KEYSTONE XL PIPELINE PROJECT

0491-SD-P4-387.0-387.7-S

KEYSTONE XL PIPELINE PROJECT PIPELINE ROUTE VARIATION FORM			
1	<b>VARIATION TYPE:</b> Refinement: <input type="text"/> Reroute: <input checked="" type="checkbox"/> Footprint: <input type="text"/> Design: <input type="text"/> Centerline: <input checked="" type="checkbox"/> Pump Station: <input type="text"/> Valve Site: <input type="text"/> CAR: <input type="text"/>		
2	<b>LOCATION:</b> Sketch: <input type="text" value="Attached"/> Pictures: <input type="text" value="N/A"/> State: <input type="text" value="SD"/> County: <input type="text" value="Meade"/> Quad Map: <input type="text" value="N/A"/> Township: <input type="text" value="011N"/> Range: <input type="text" value="012E, (013E)"/> Aerial Map: <input type="text" value="See attached map sheet"/> Section: <input type="text" value="012, (07)"/> Centerline: <input type="text" value="6/11/2013"/> MP: <input type="text" value="387.02"/> to <input type="text" value="387.67"/>

**KEYSTONE XL PROJECT**  
**RV-0491-01 CL CHANGES**

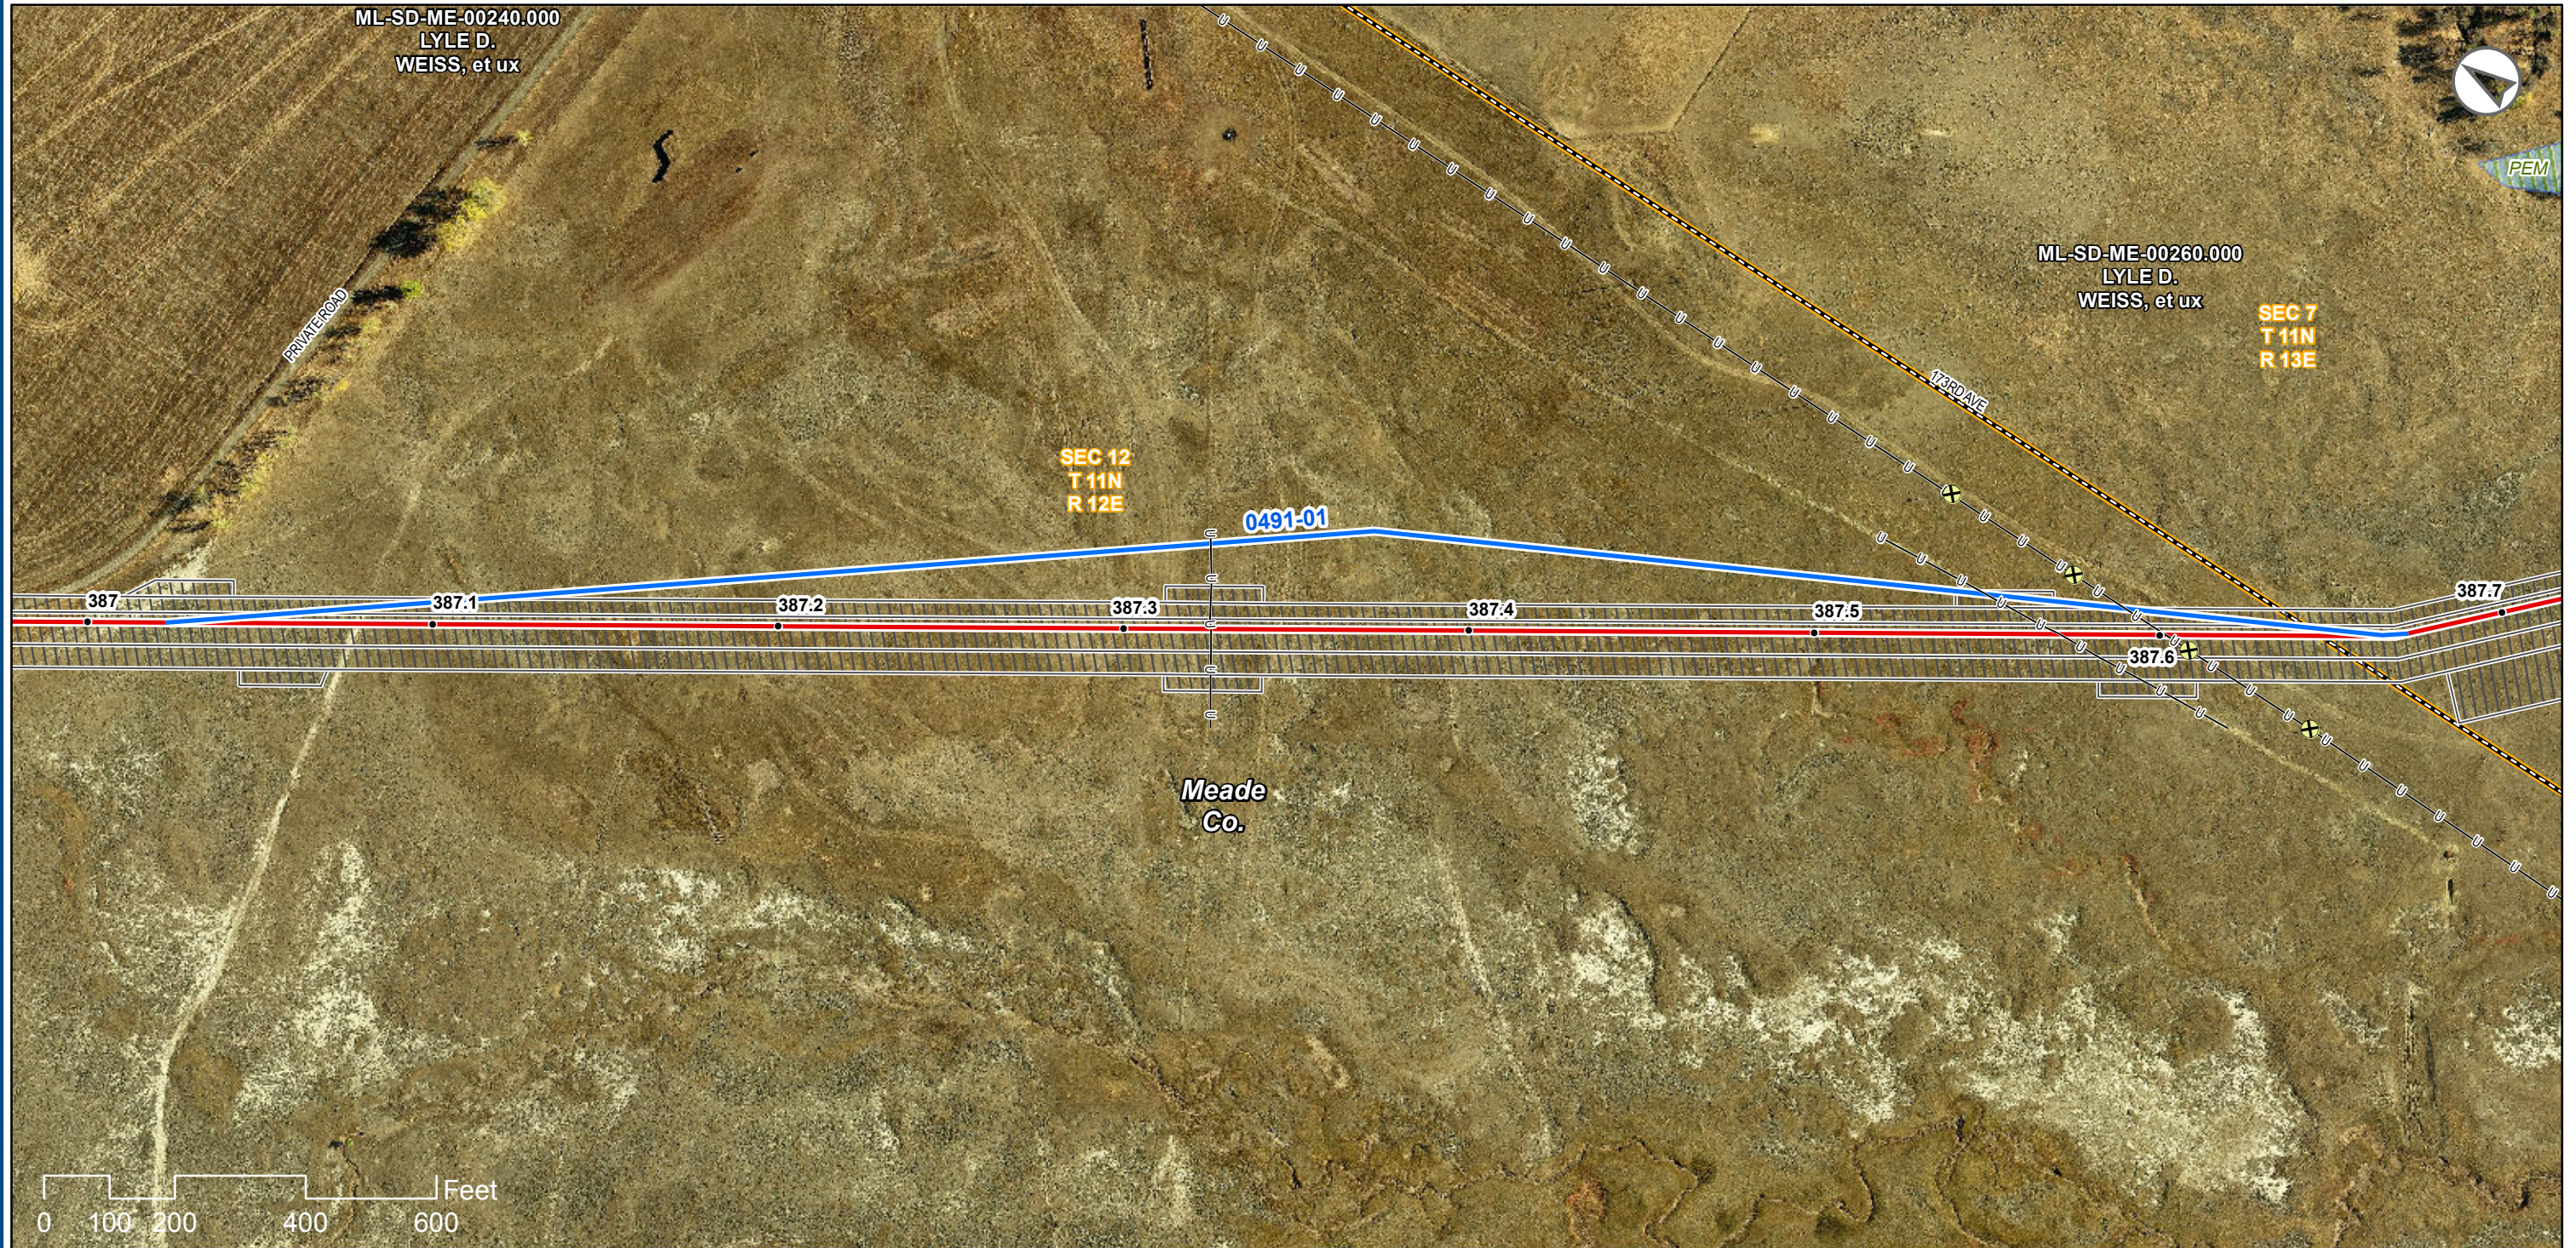
3	<b>REASON FOR ROUTE VARIATION</b> (Please include reason for route variation): The primary reason for this CL reroute is to shift CL away from drainage channel per 90% alignment sheet review. This CL reroute has been field verified by civil survey.  This reroute is requested by Engineering.		
	<b>DETAIL ROUTE VARIATION</b> (Please describe route variation in detail): The proposed reroute begins at ~MP 387.0 and deviates ~8° northeast of the current CL. It extends for ~1,855 ft in this direction before turning southeasterly for ~1,589 ft. to reconnect with the current CL near MP 387.7  Tracts Impacted: ML-SD-ME-00240.000 (Lyle D. Weiss, et ux) ML-SD-ME-00260.000 (Lyle D. Weiss, et ux)		
	<b>ADDITIONAL IMPACTS</b> (Please include any additional impacts which may affect cost; crossings, induction bends, etc.):  The proposed route variation falls within the current environmental surveyed corridor, so no additional costs associated with surveys will be incurred.
